**AGENDA
TECHNICAL REVIEW COMMITTEE
REGULAR MEETING
OCTOBER 24, 2024
10:00 AM
CITY HALL COMMISSION CHAMBERS
204 ASH STREET
FERNANDINA BEACH, FL 32034**

**AGENDA
TECHNICAL REVIEW COMMITTEE
REGULAR MEETING
AUGUST 22, 2024
10:00 AM
CITY HALL COMMISSION CHAMBERS
204 ASH STREET
FERNANDINA BEACH, FL 32034**

4.1 TRC 2024-0006 - SCOTT LOCKWOOD, AGENT FOR BAPTIST MEDICAL CENTERS, 1210 VINTAGE WAY

DARIUS PROPERTY
1520 SOUTH 14TH STREET
FERNANDINA BEACH, FLORIDA 32034

SILT FENCE APPLICATIONS

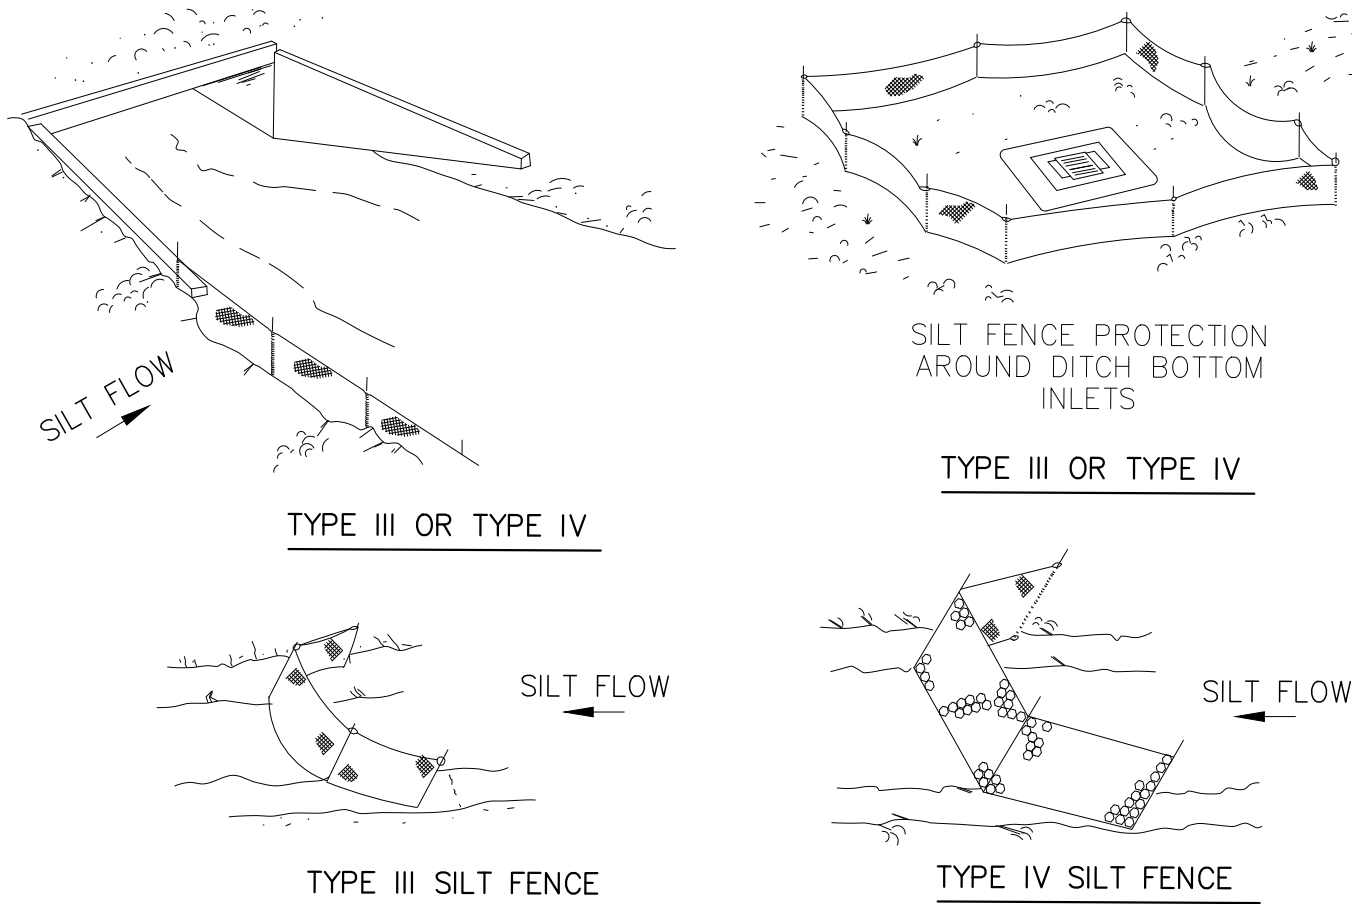
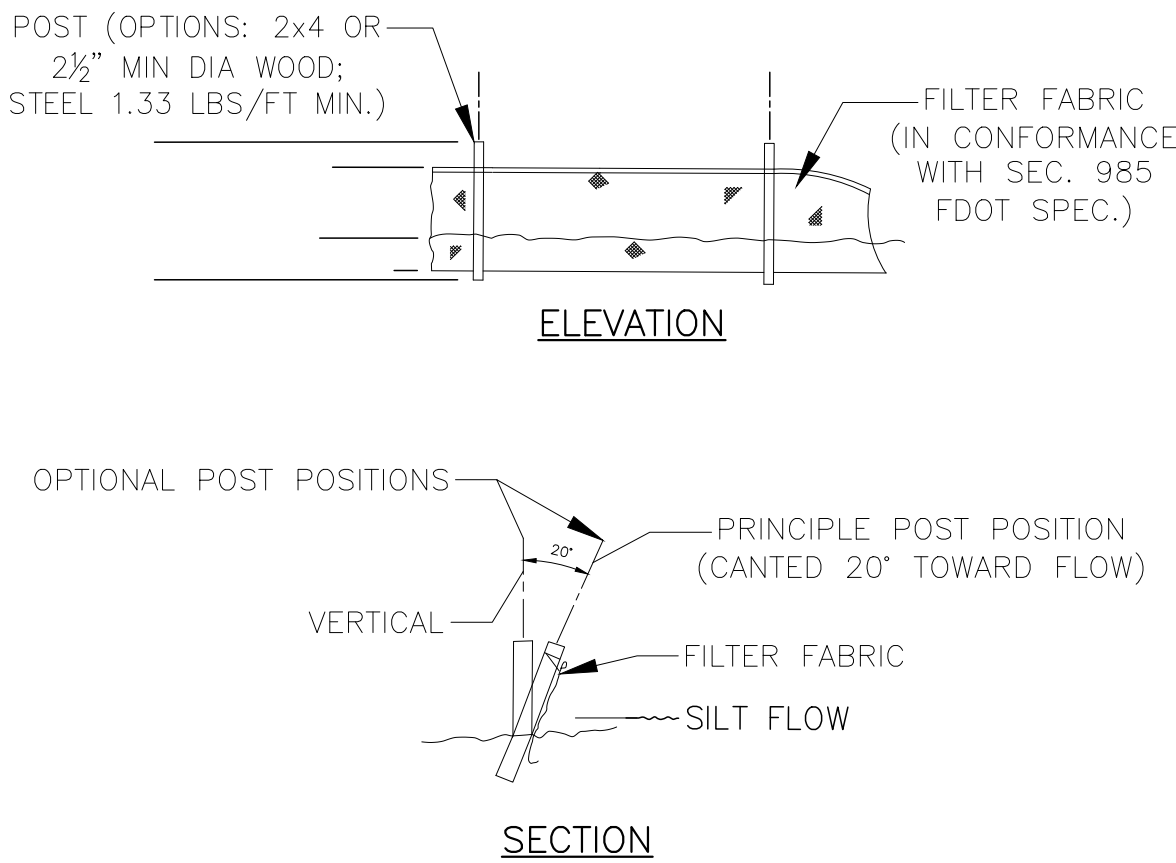
- Please provide the utility plans and details.
- Erosion control details and locations need to be included.
- Please provide a cross-section showing the transition to existing grade and retention walls.
- There is a ditch running on the Southern portion of the property in the 20' drainage easement. Please show plans to maintain the existing flow and provide who is going to maintain it.
- Please provide details and locations of the overflow weir.
- Please provide more information on the stormwater system.
- The Saturated Horizontal Hydraulic Conductivity does not match the geo report.

Silt fence details have been added to a new sheet, DT-2.

SITE LIGHTING DETAIL

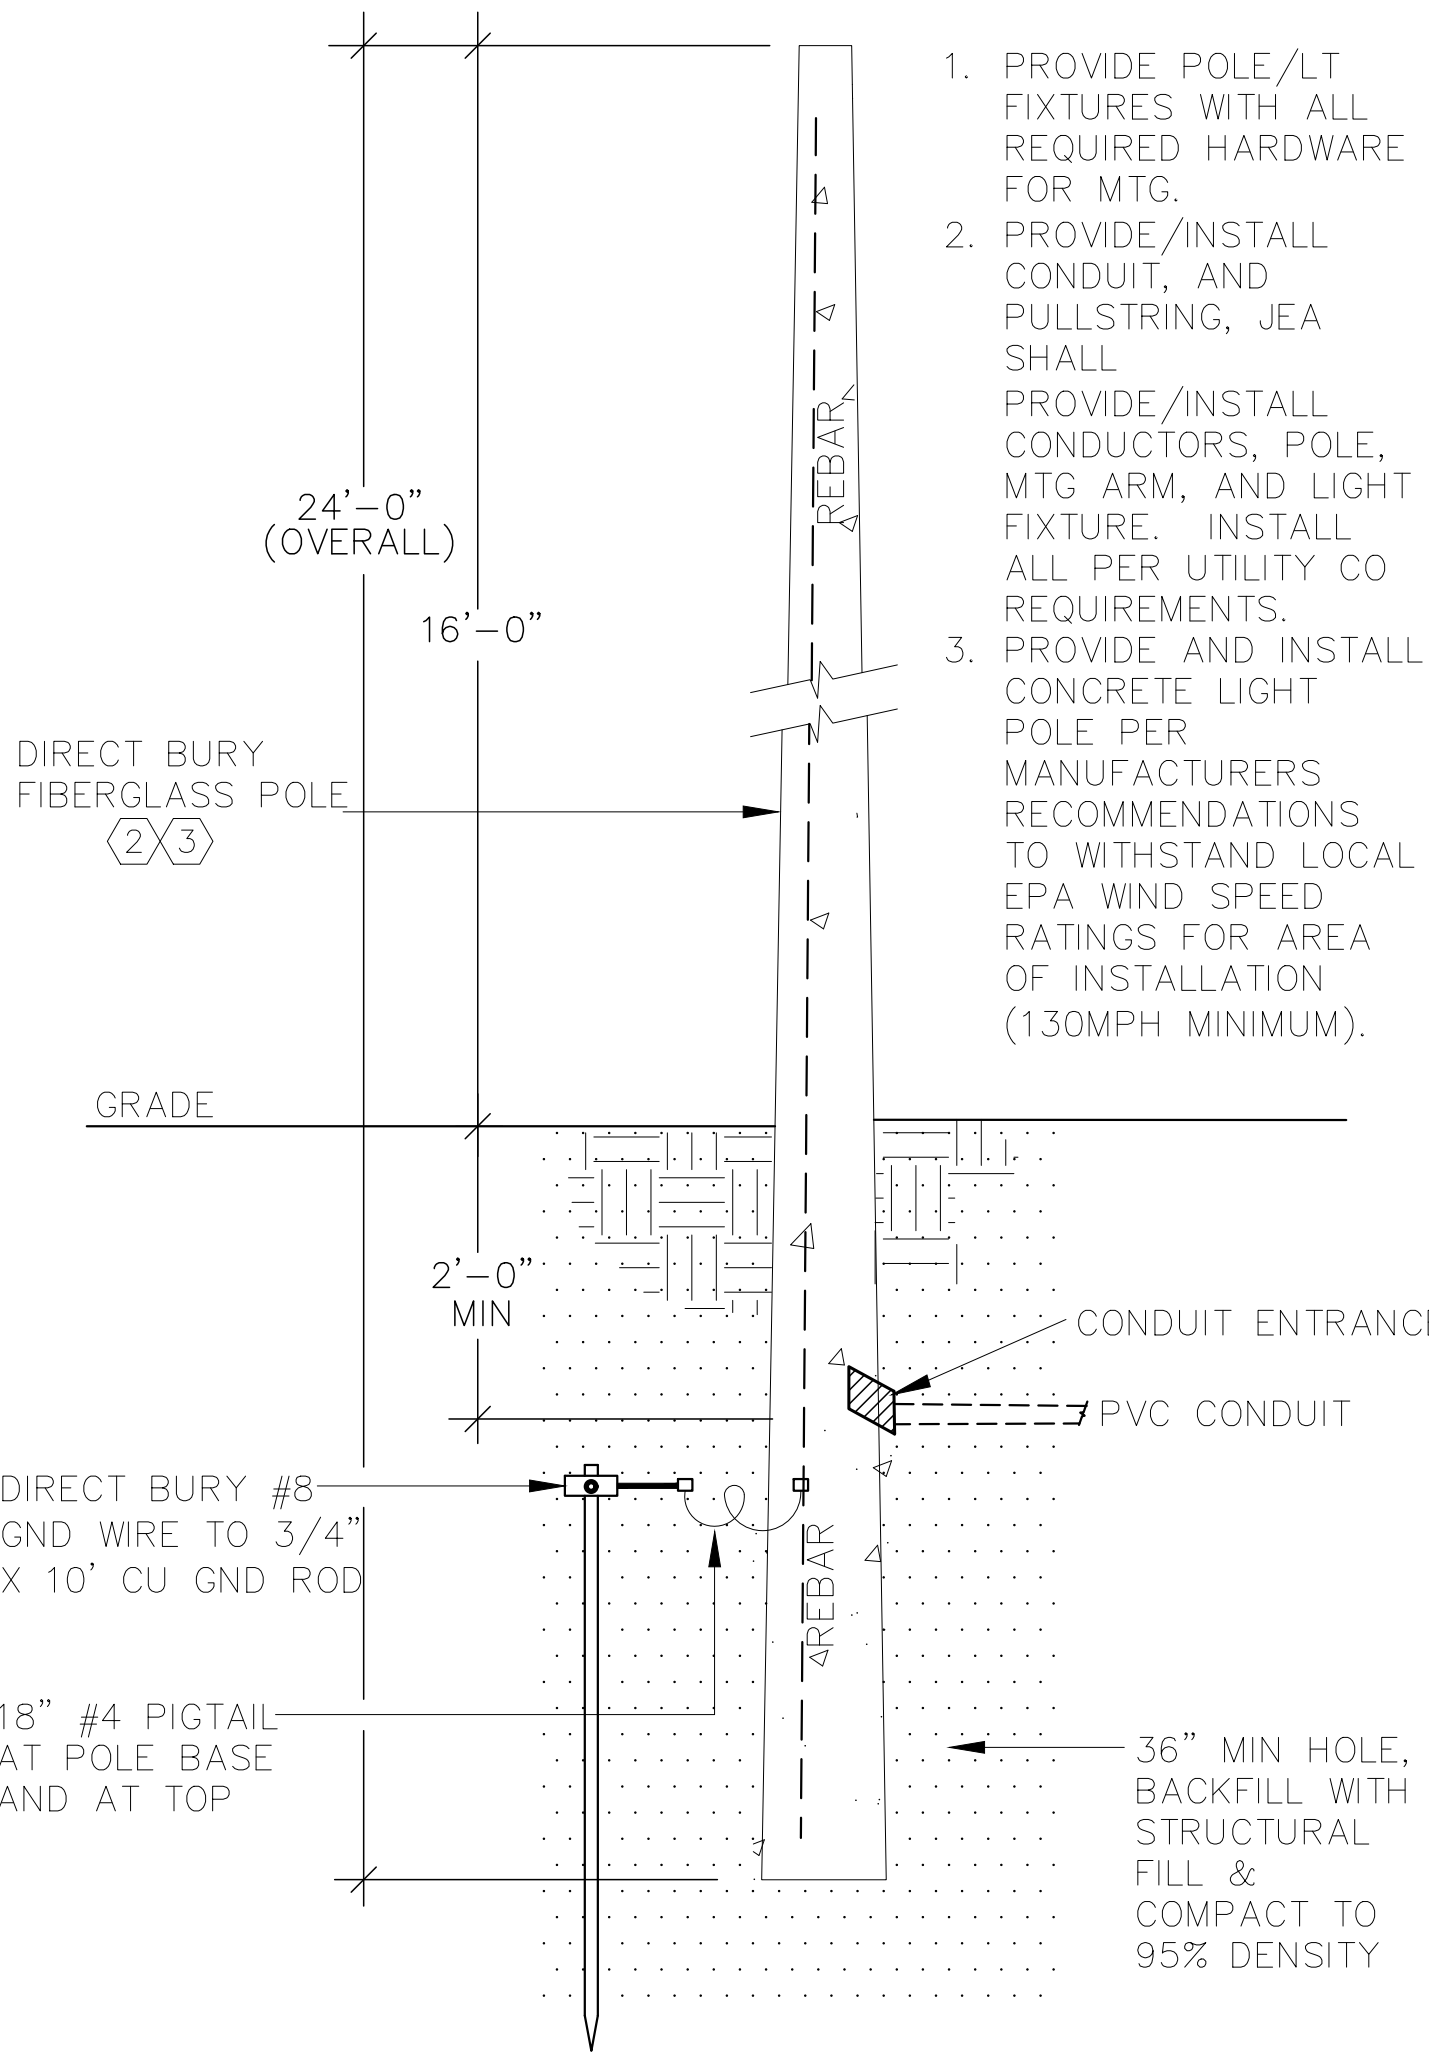
7.01.04 (C)(5) - Please show lighting plan and location of fixtures.

Lighting fixtures have been added to the site plan. See sheet GE-1 and UT-1. A photometric plan has been scheduled and will be submitted once received.
